RE: Bethlehem Landfill Company
Northern Realignment
Amended Preliminary/Final
Land Development Plan, Site Plan and Lot Consolidation
Our file: b/1162.4/NR/LDP/102620

Bethlehem Landfill Company (“BLC”) hereby submits the following regarding the above referenced project, in response to a review letter issued by Hanover Engineering on September 17, 2020:

RIVERSIDE DRIVE FUTURE RESERVED

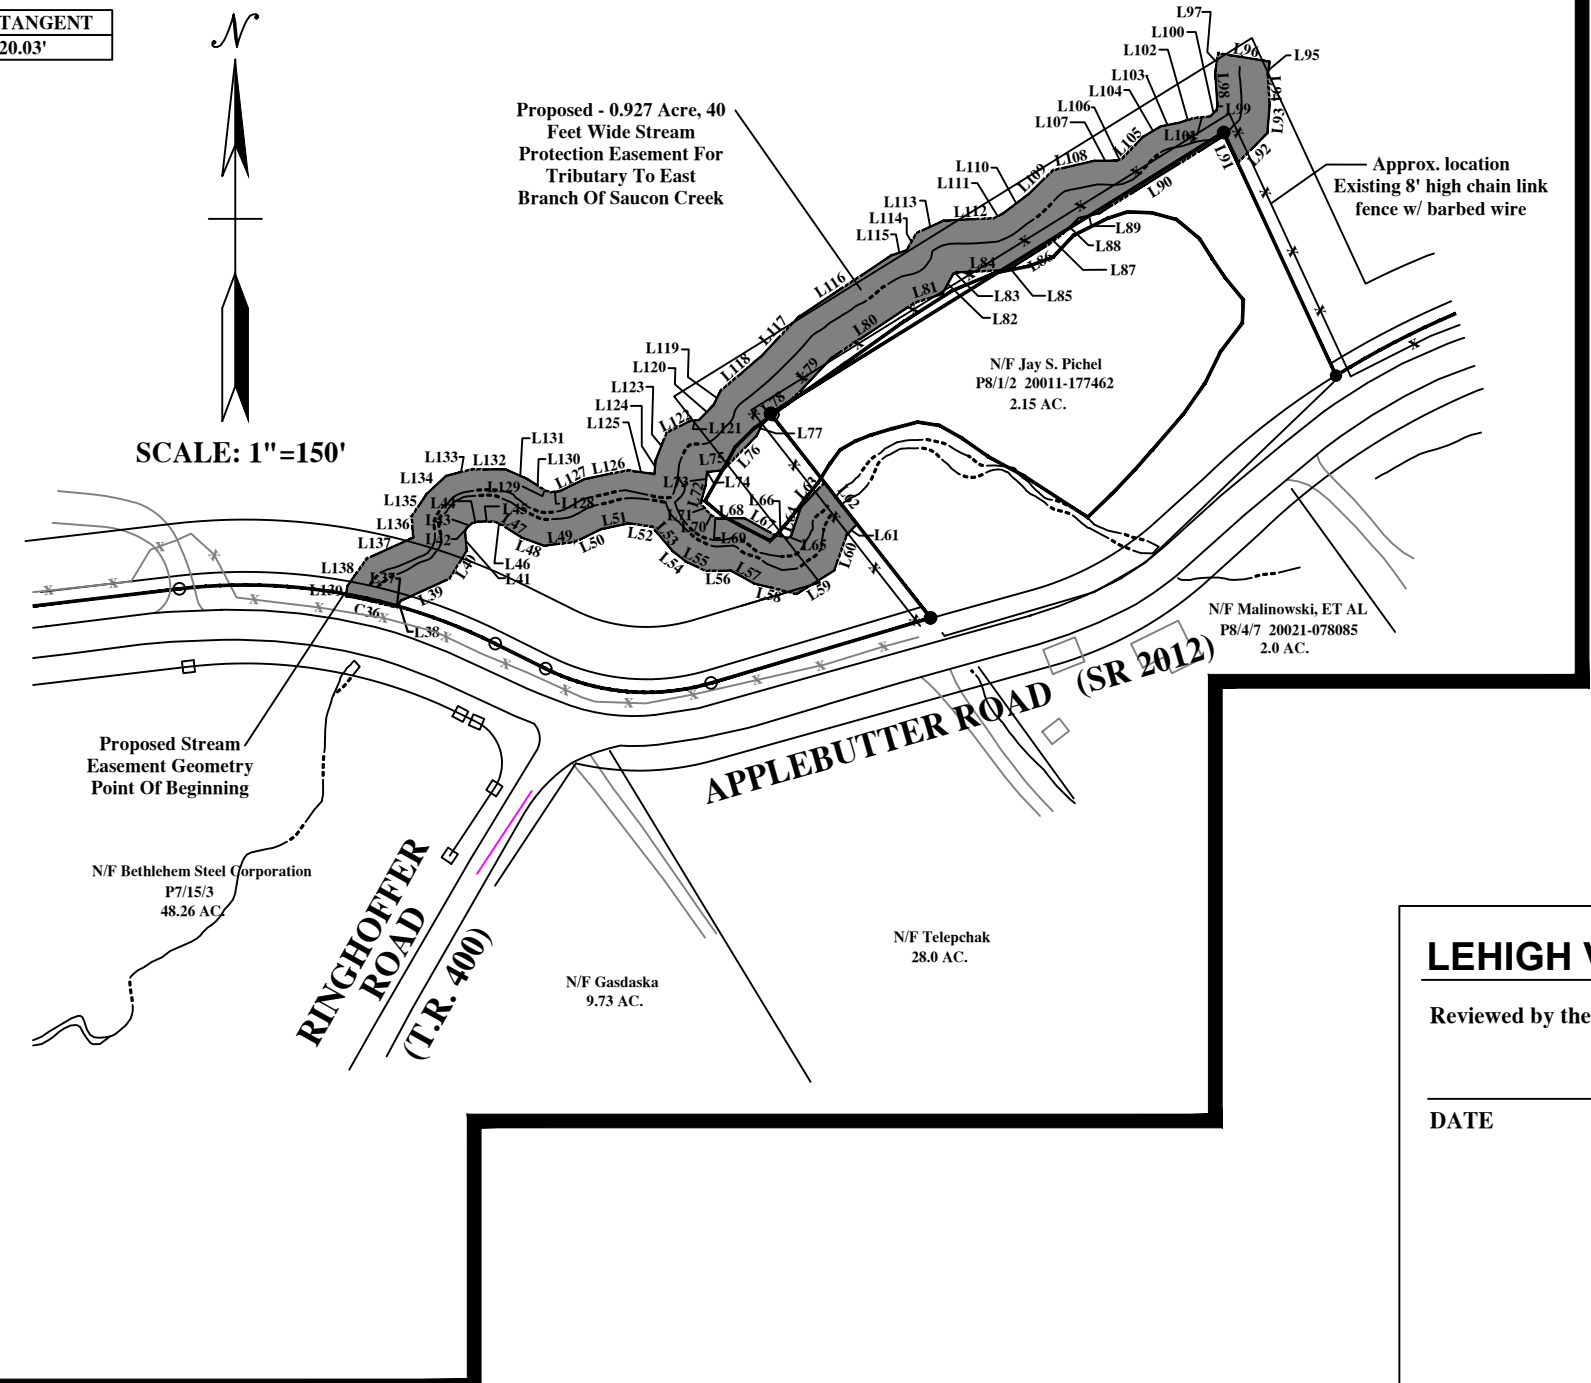
- d. The proposed Riverside Drive right-of-way information is not provided on the Plans; therefore, we cannot confirm the right-of-way area listed on Sheet 2.

- 18. Section 145-33.D.(15) – The following comments regarding the proposed easements shall be satisfactorily addressed:
 - a. Easement line information is not provided for the proposed easements on the former Helms and Redington parcels; therefore, we cannot confirm the easement area listed on Sheet 2.

Plan Sheets #2 and #3 of 17 have been revised to include a bearing and distance description of the ultimate future reserved right-of-way area for Riverside Drive which is located within the area of the consolidated lot.

Plan Sheet #3a of 17 has been added to the set to include details and descriptions of all easements on the former Helms and Redington Tracts.

PLANTINGS TO BE RELOCATED ALONG BASIN #2

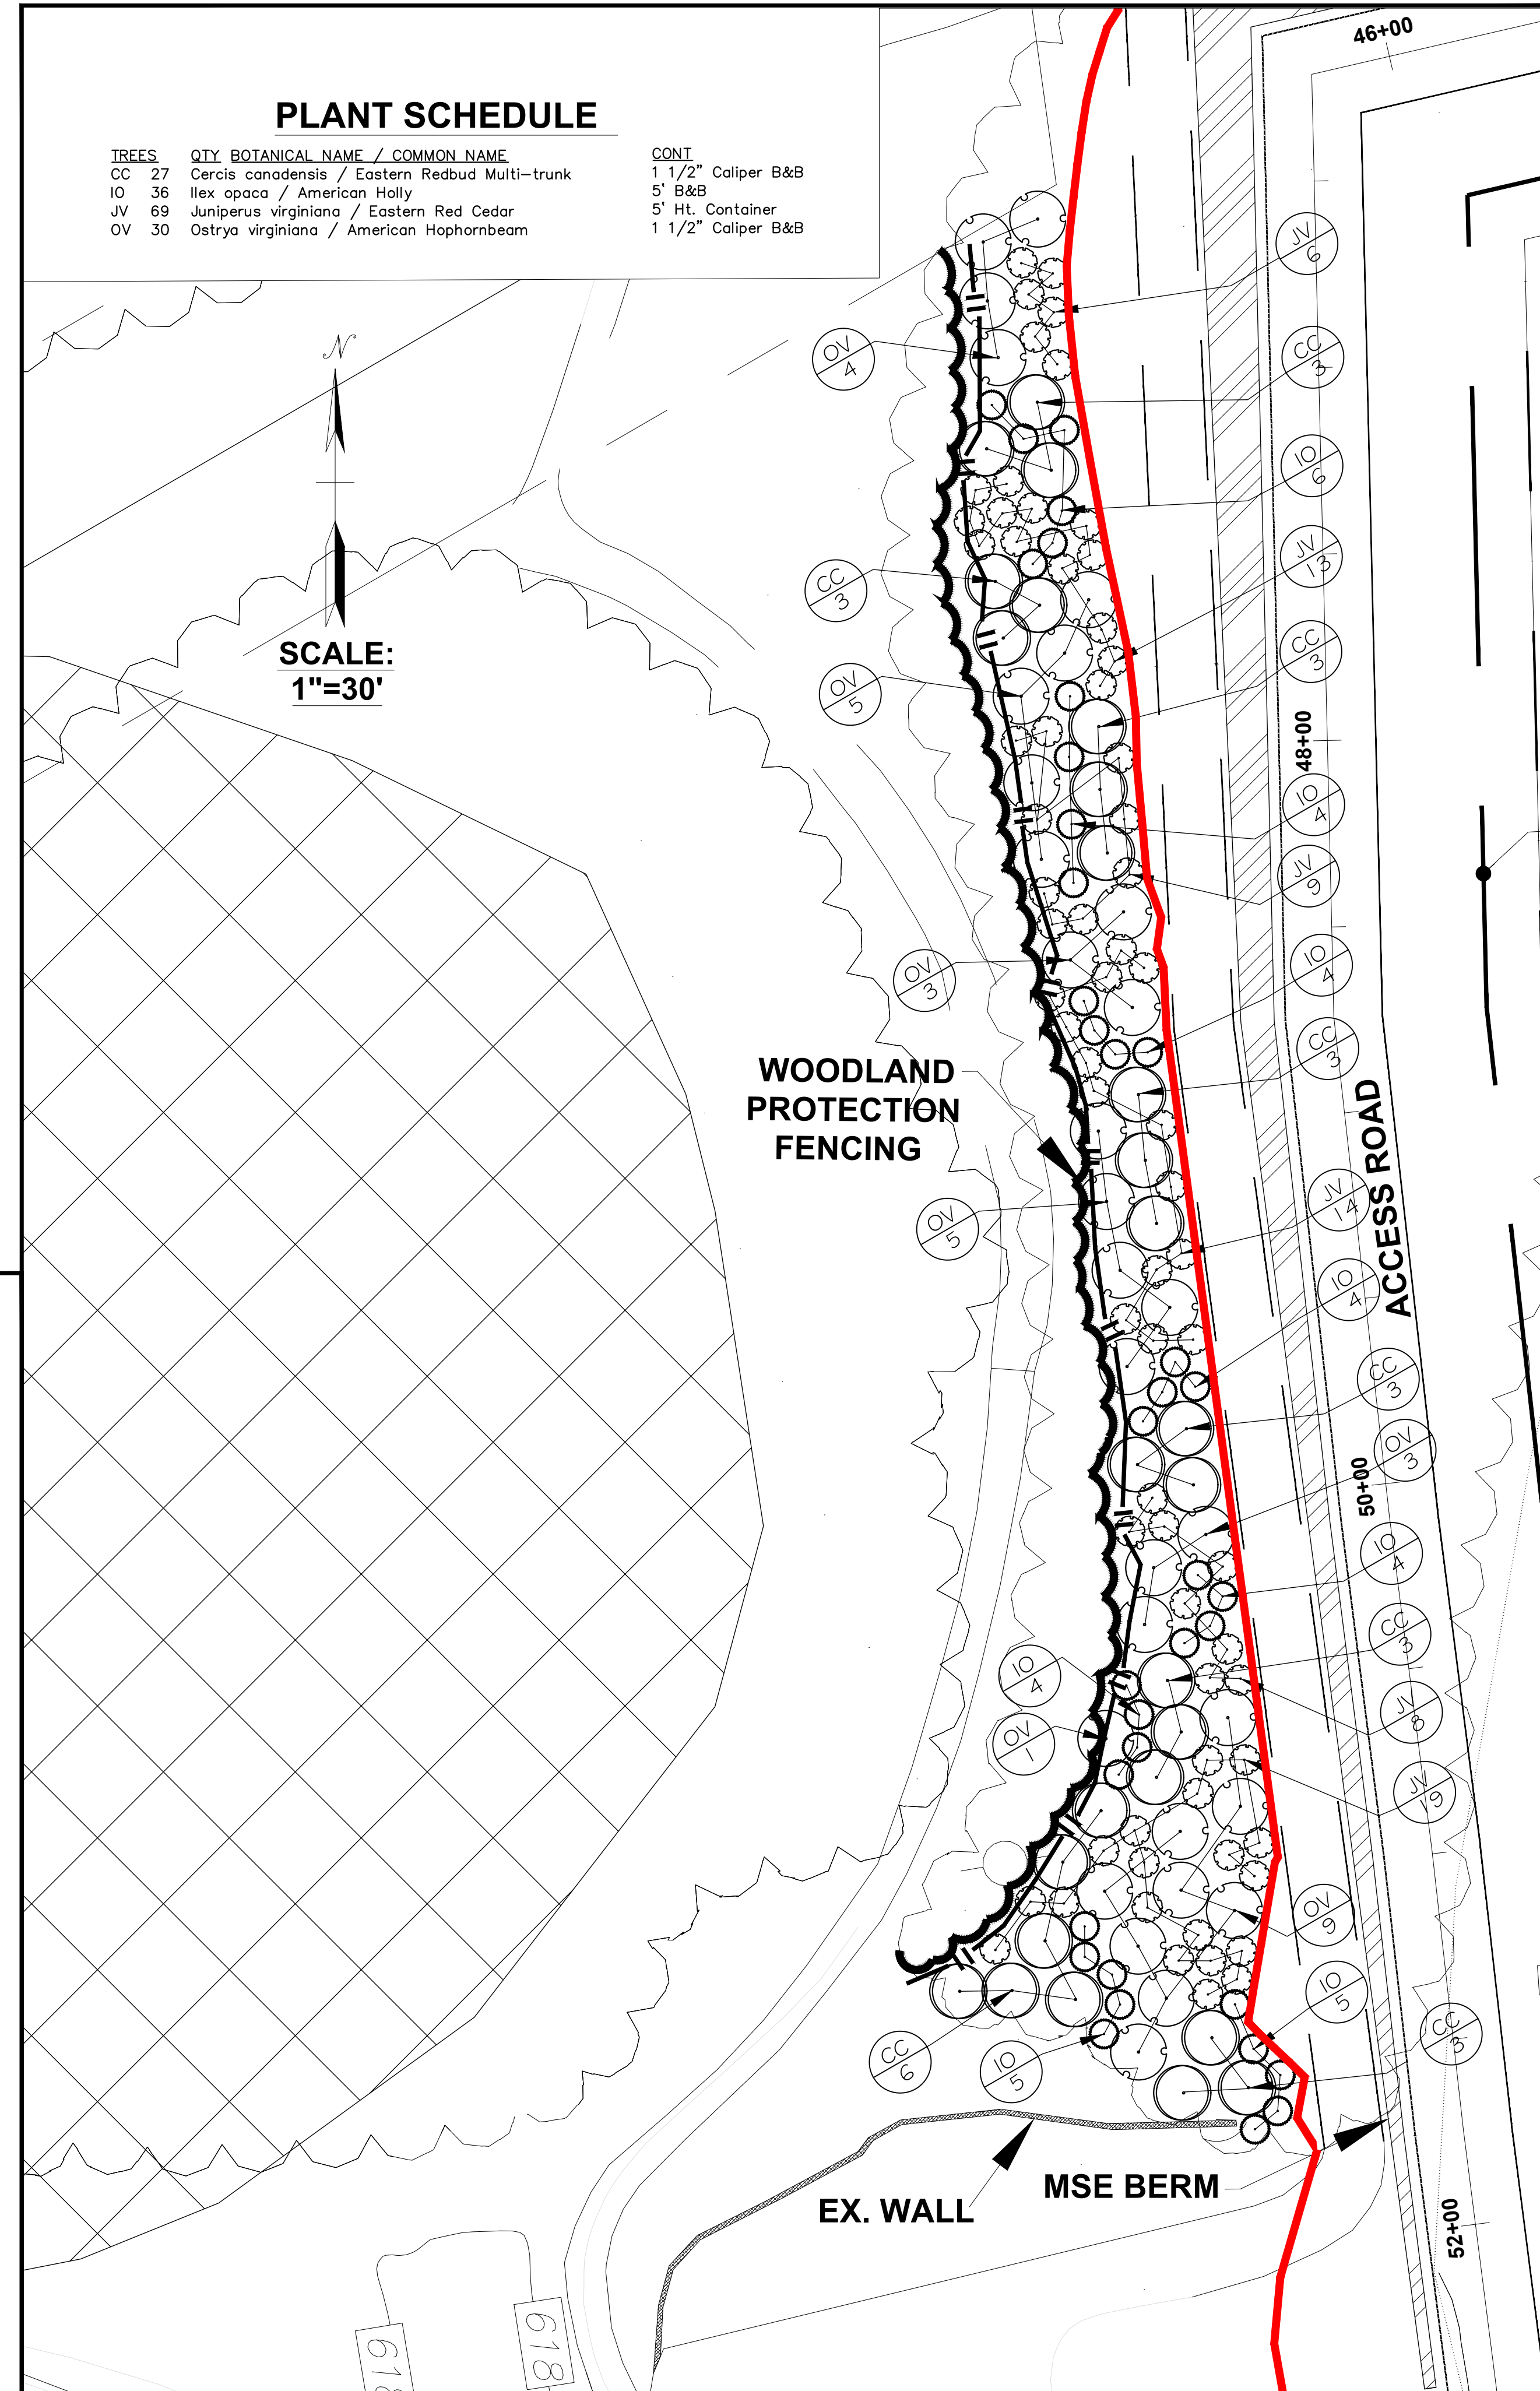
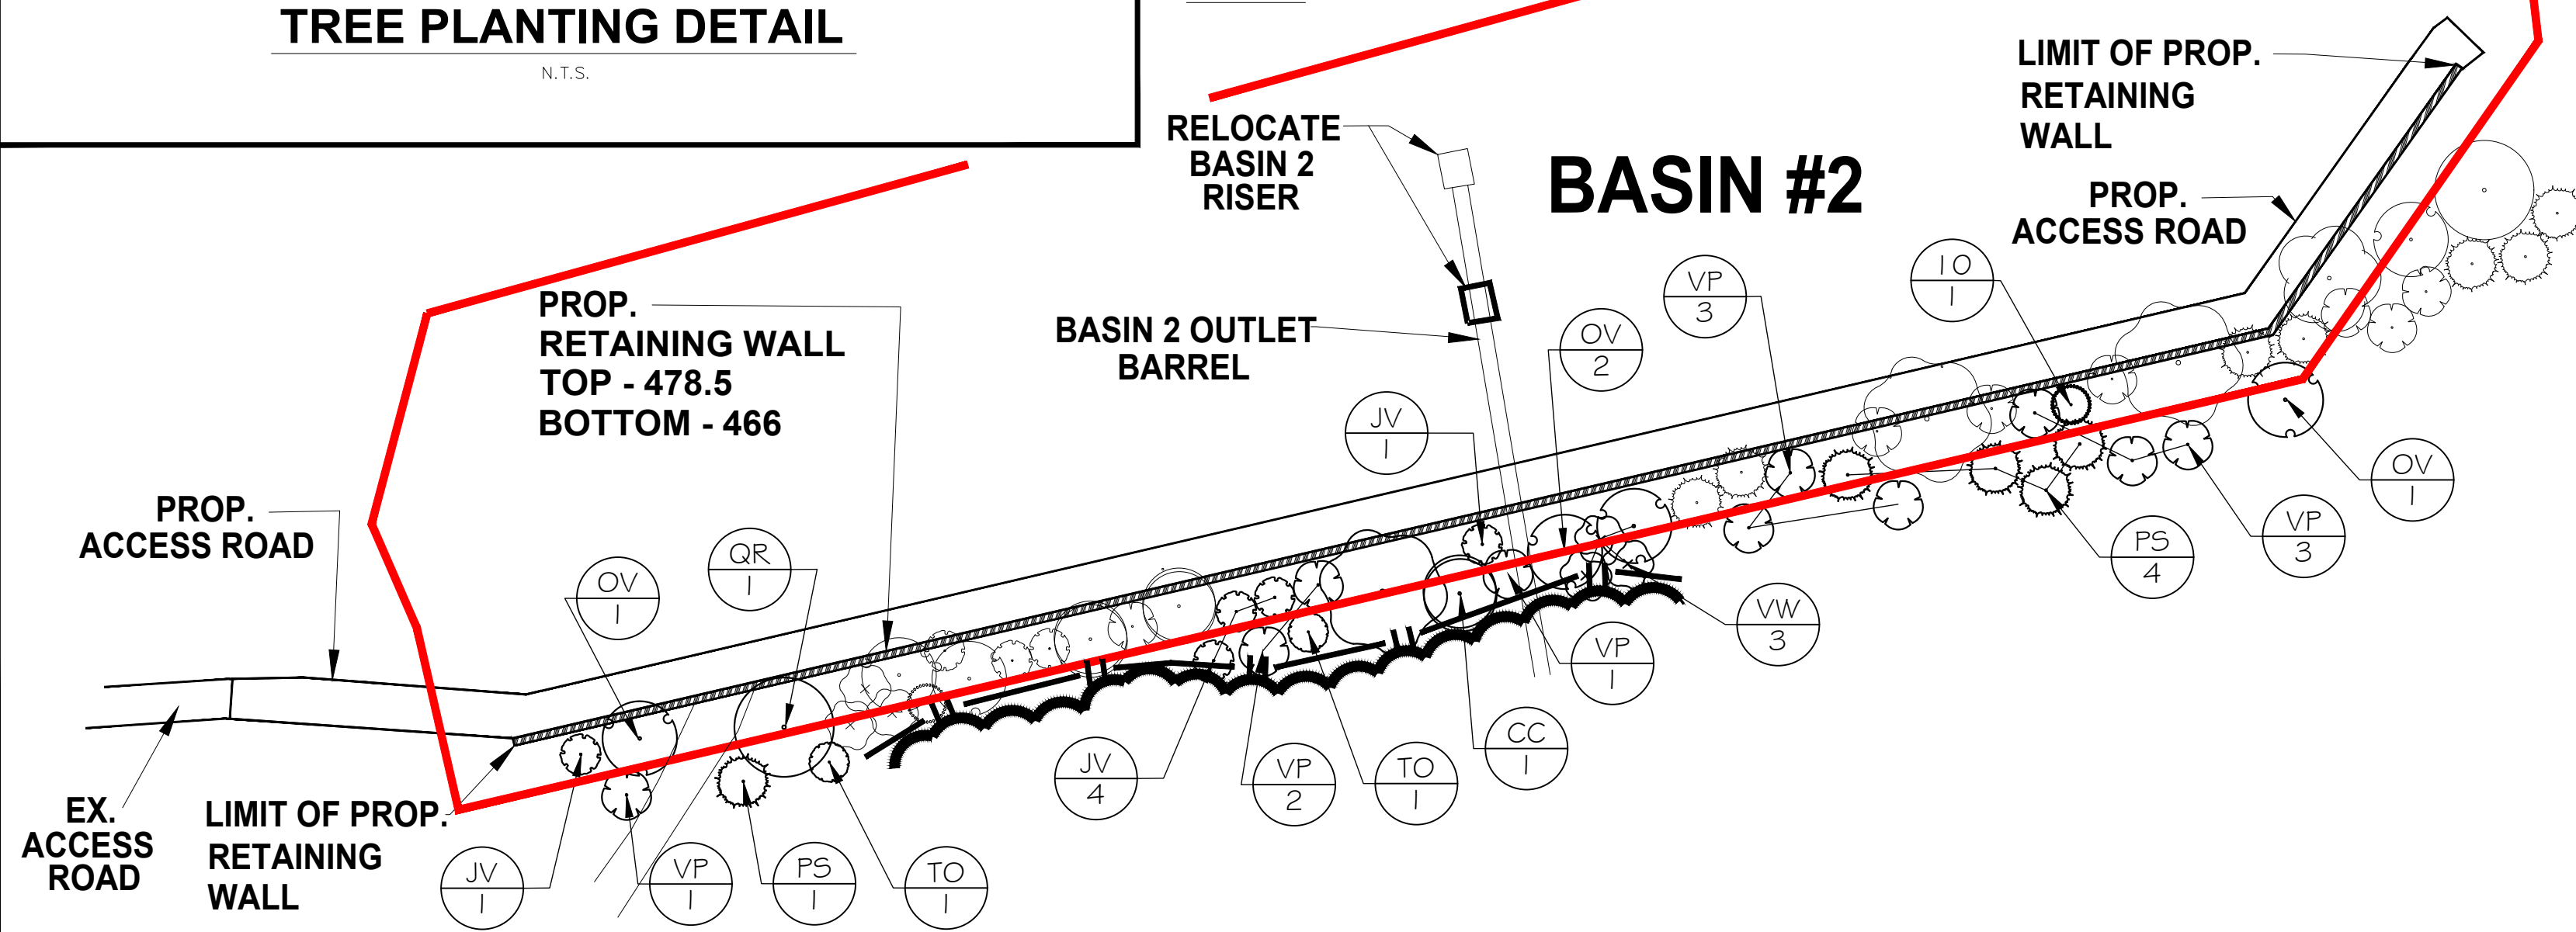
- 21. Section 145-33.E.(7) – The quantities of American Holly (IO) and Eastern Red Cedar (JV) trees listed in the Plant Schedule on Sheet 17 shall be checked and revised to be consistent with the plan view.

Plan Sheet #17 for 17 has been revised to correct the quantities list to match the plan view for the proposed number of plantings.
